LANDMARK COMMISSION

FILE NUMBER: COA-26-000034
LOCATION: 3712 Ruskin St.
STRUCTURE: Contributing
COUNCIL DISTRICT: 7
ZONING: PD-595

A Predesignation Certificate of Appropriateness to restore main building in fenestration, roof form/profile, and cladding -- correction of unauthorized work.

PROPOSED FLOOR PLAN

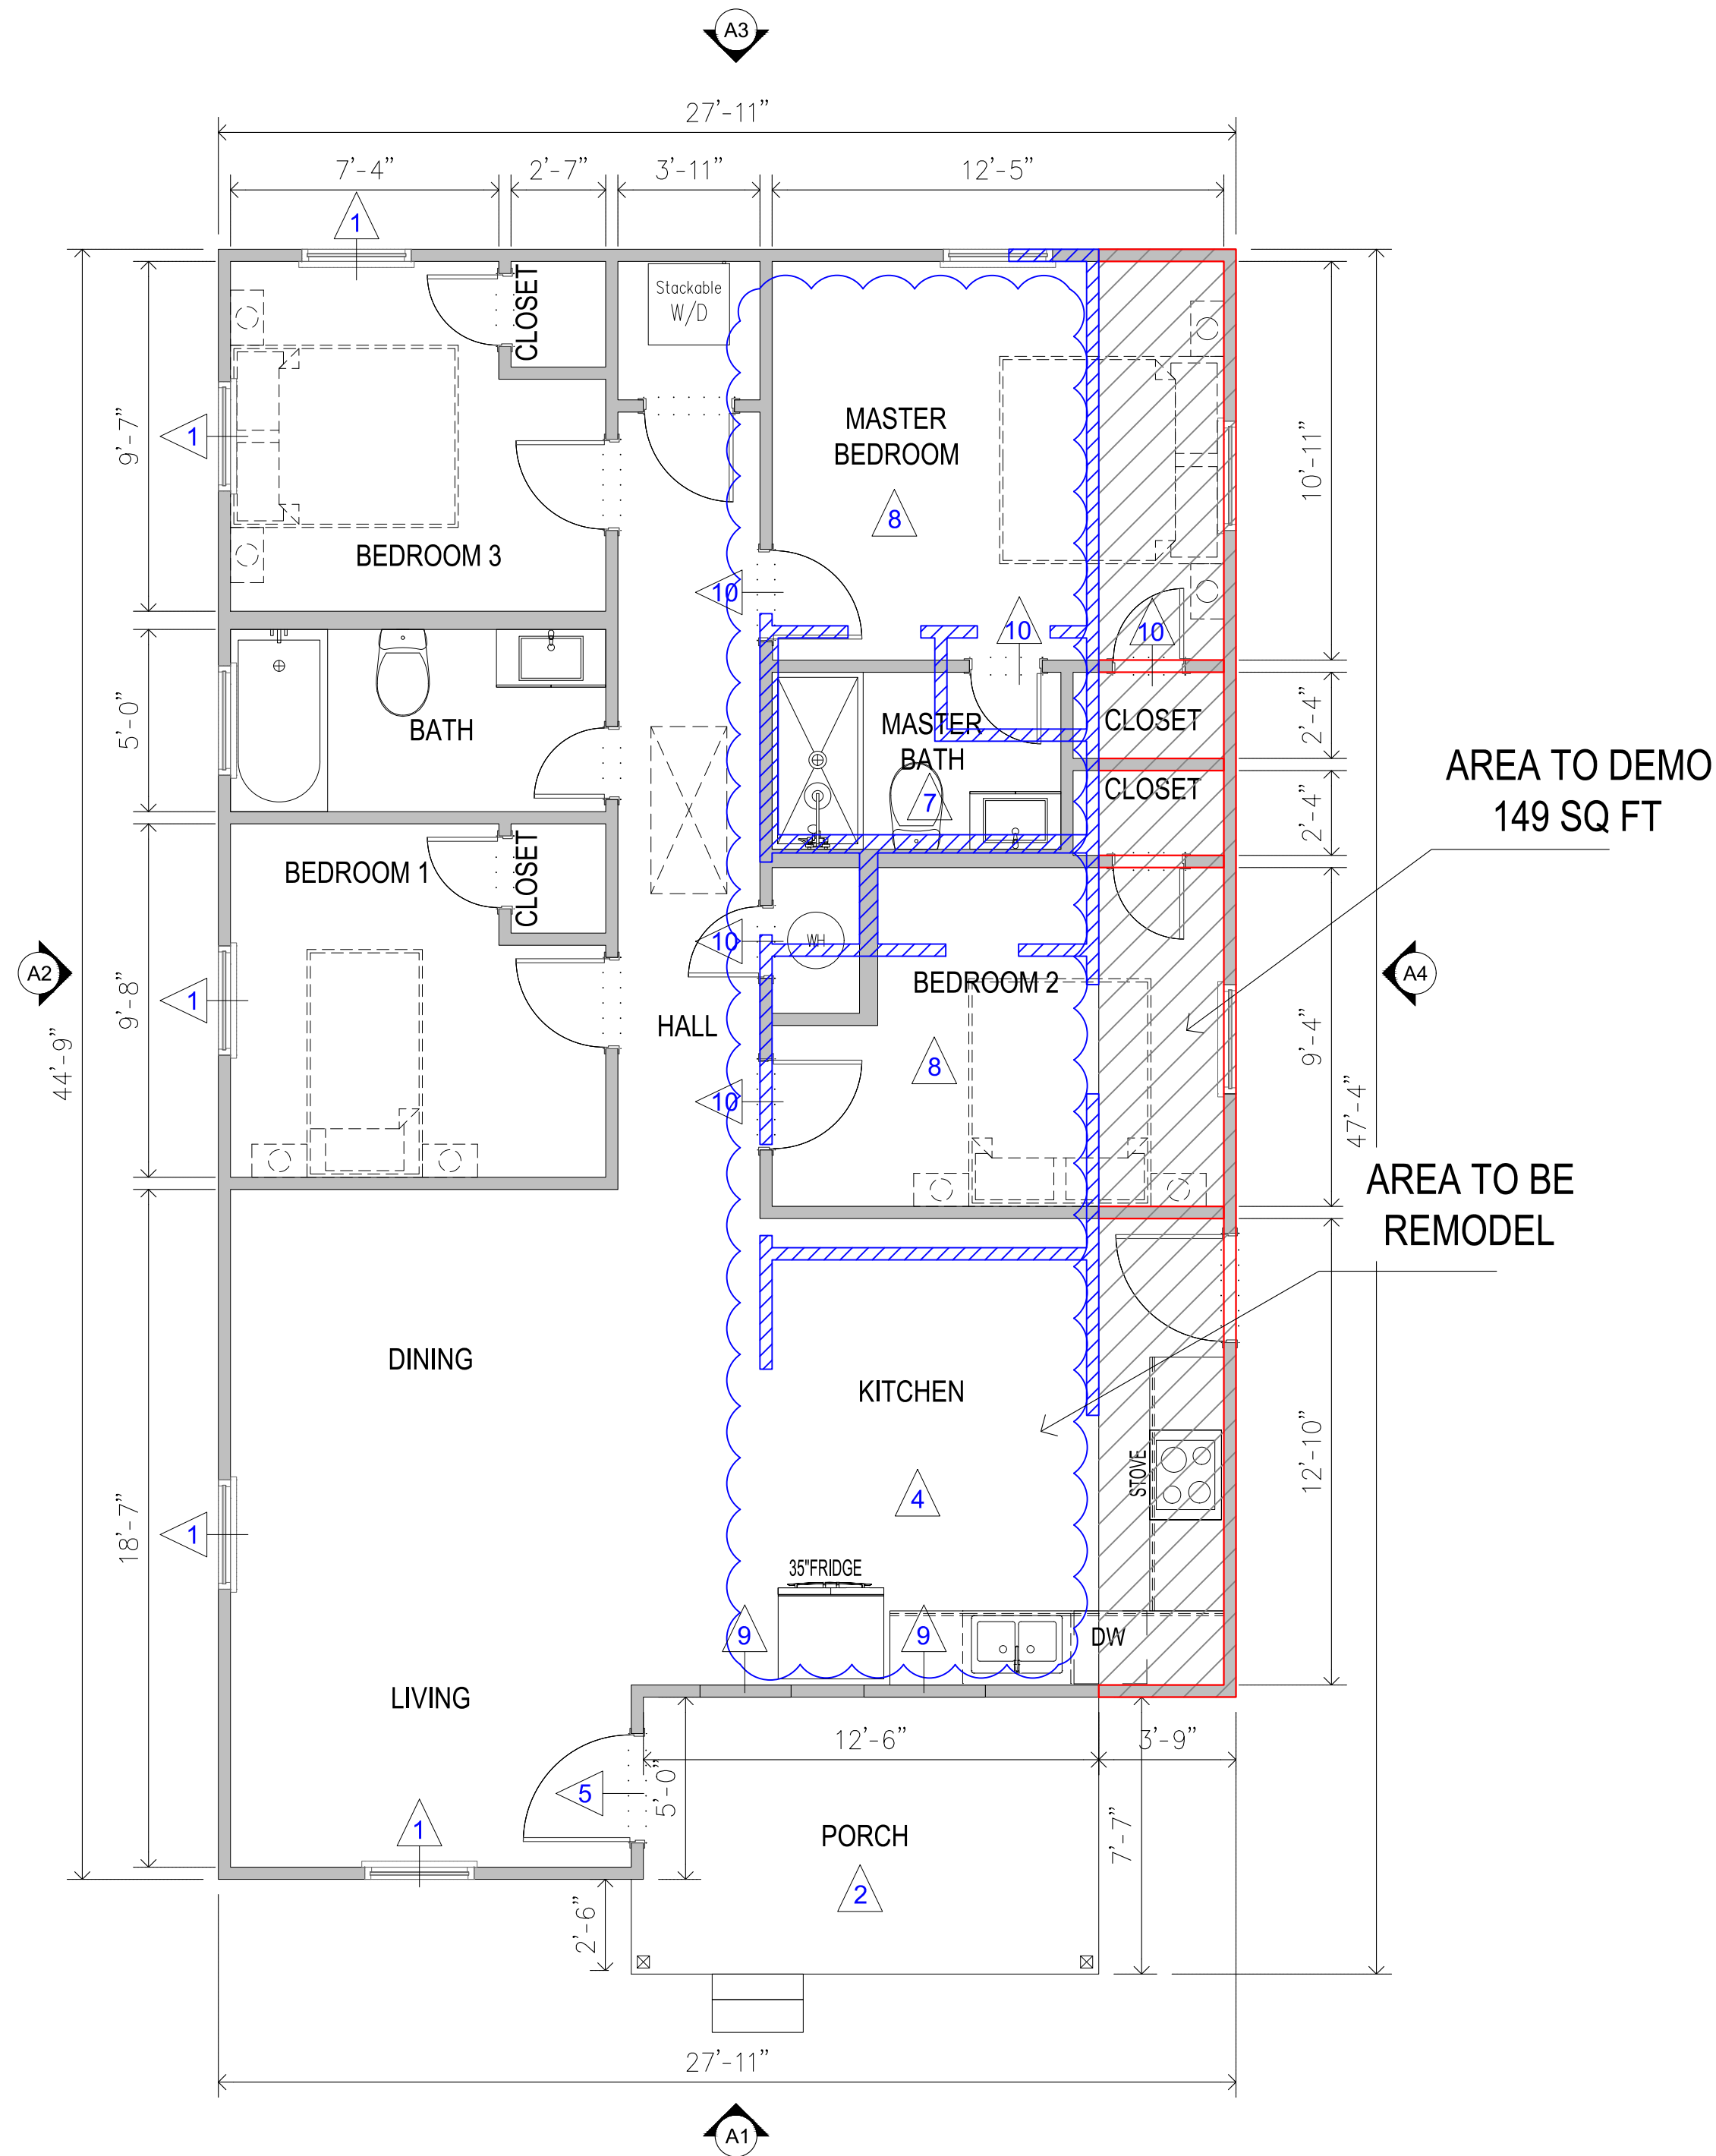
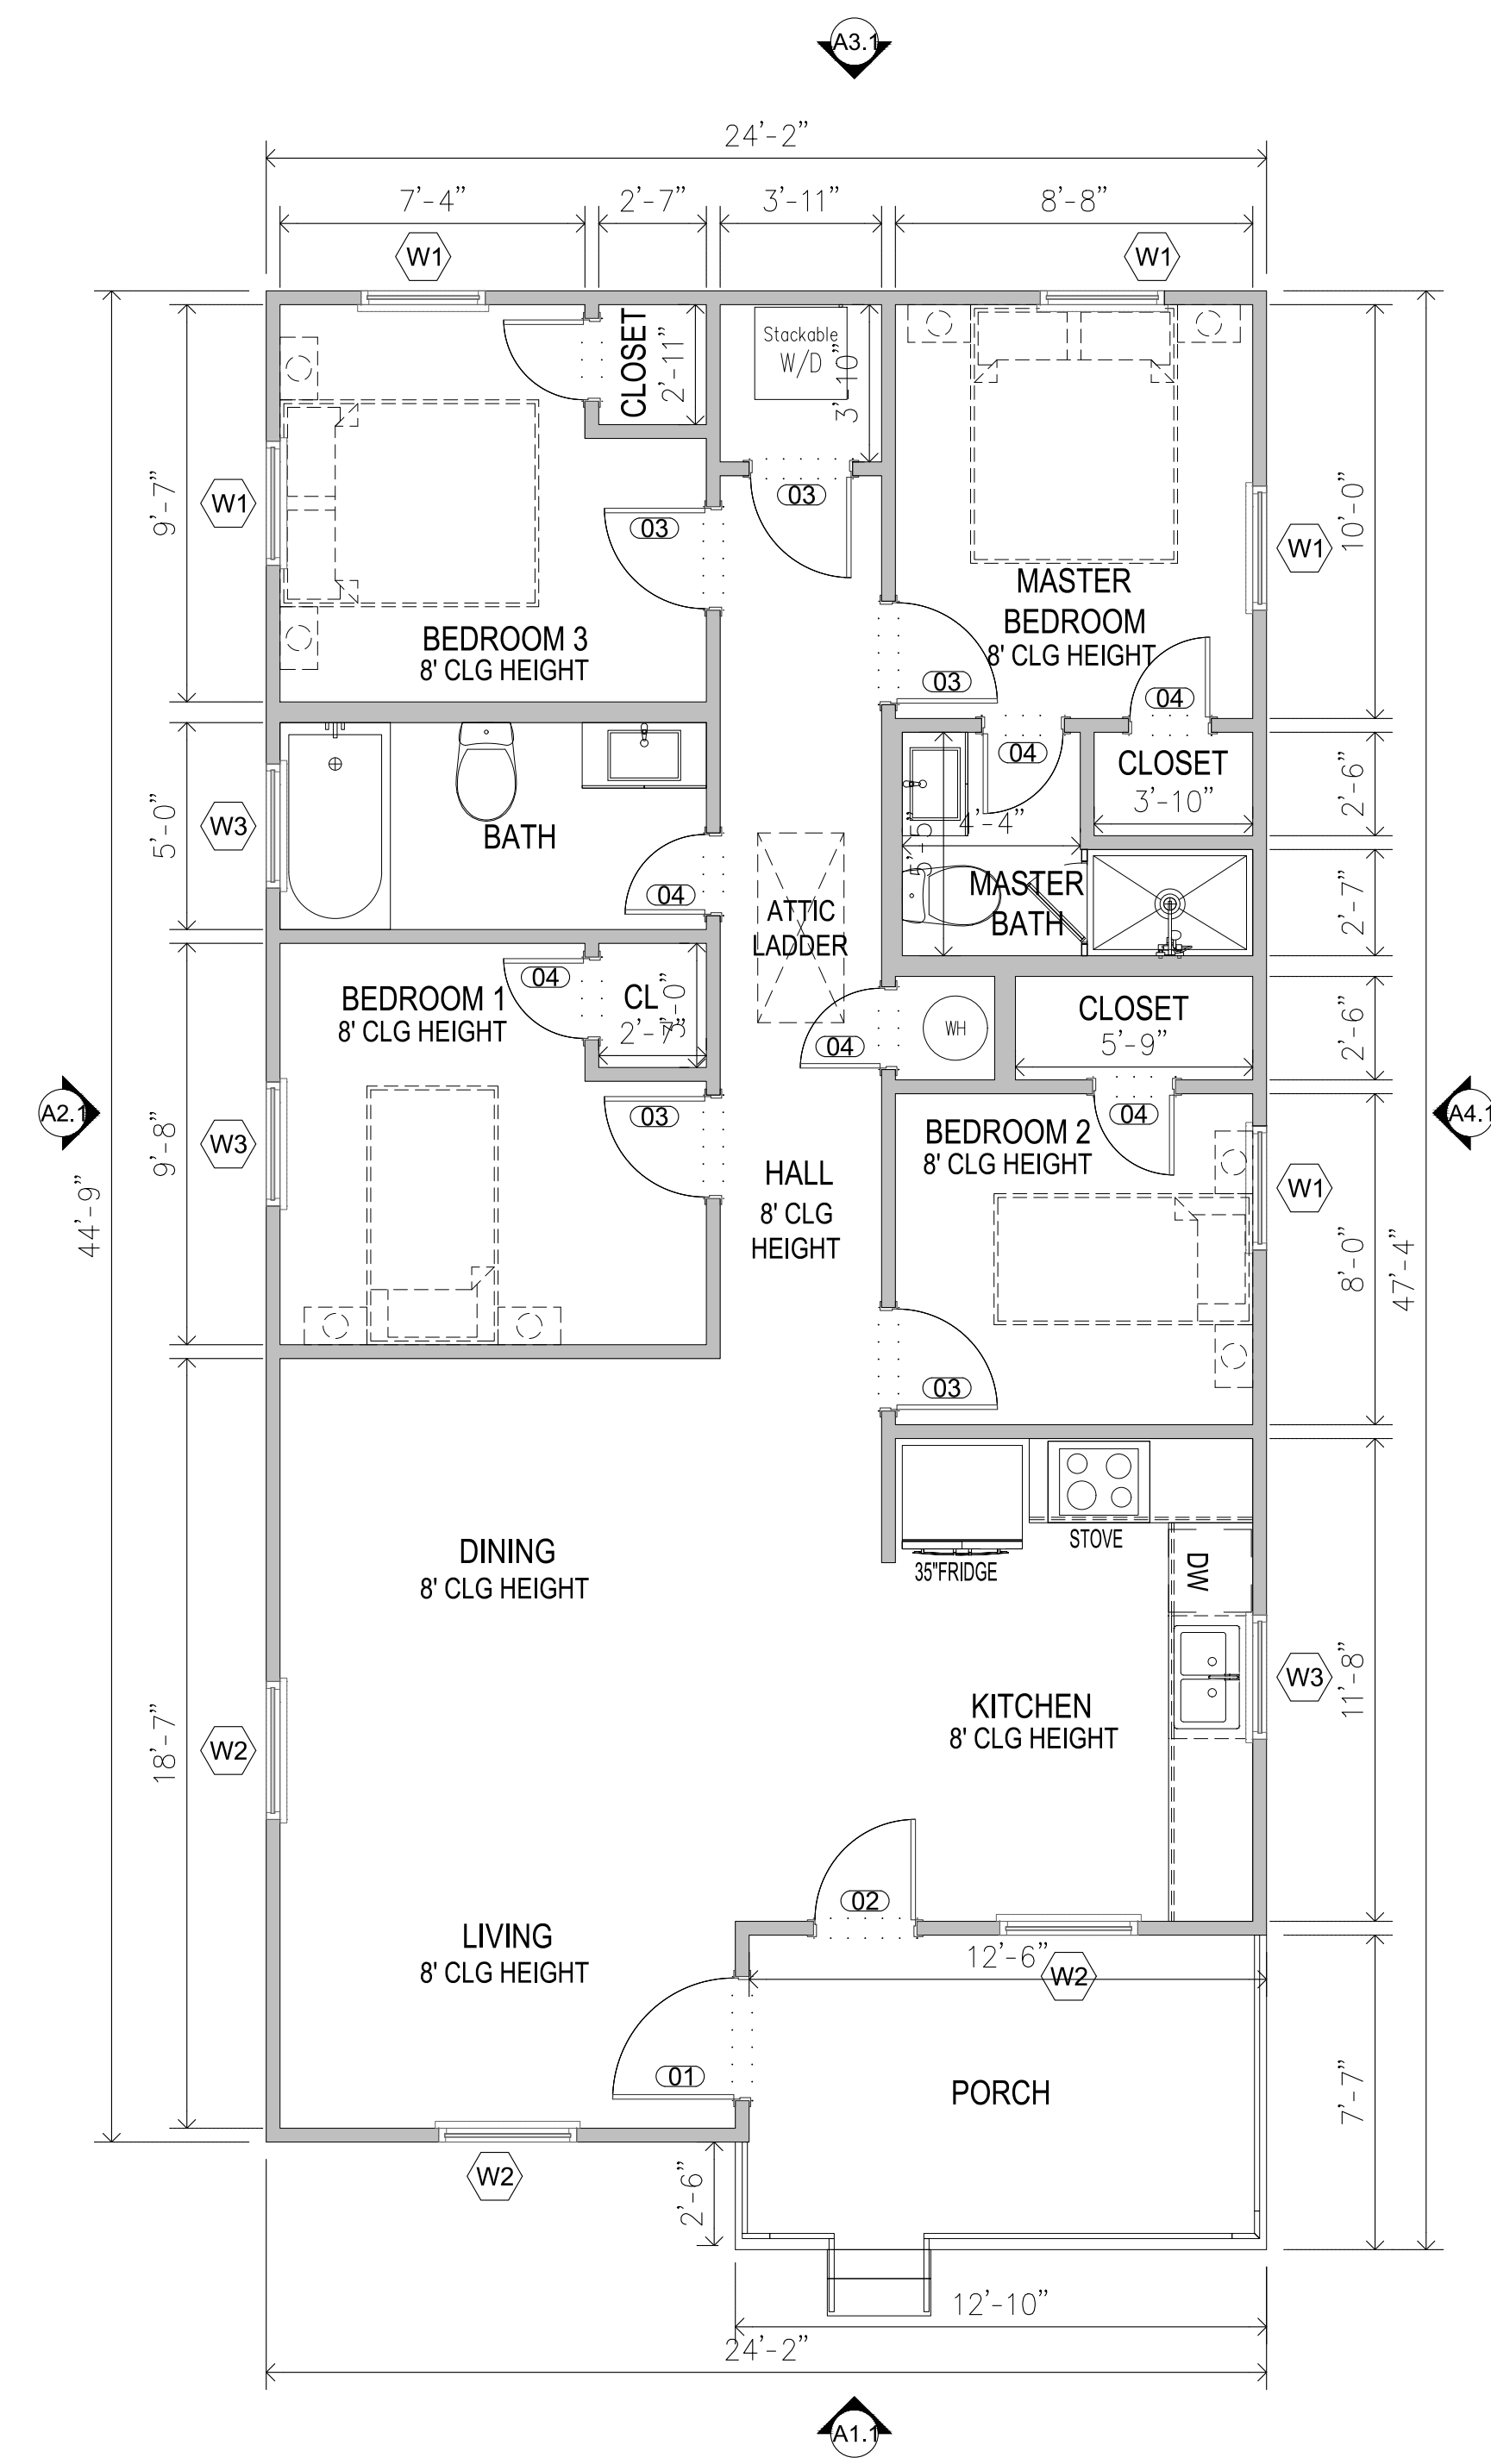
1. No quorum – comments only. Supportive, with the following comments:
2. Restore the house to its original architectural style.
3. Restore all details and ornamentation to its original size.
4. Remove floor plans from drawings.
5. Show clear comparison(s) between existing (unauthorized work) and original historic.
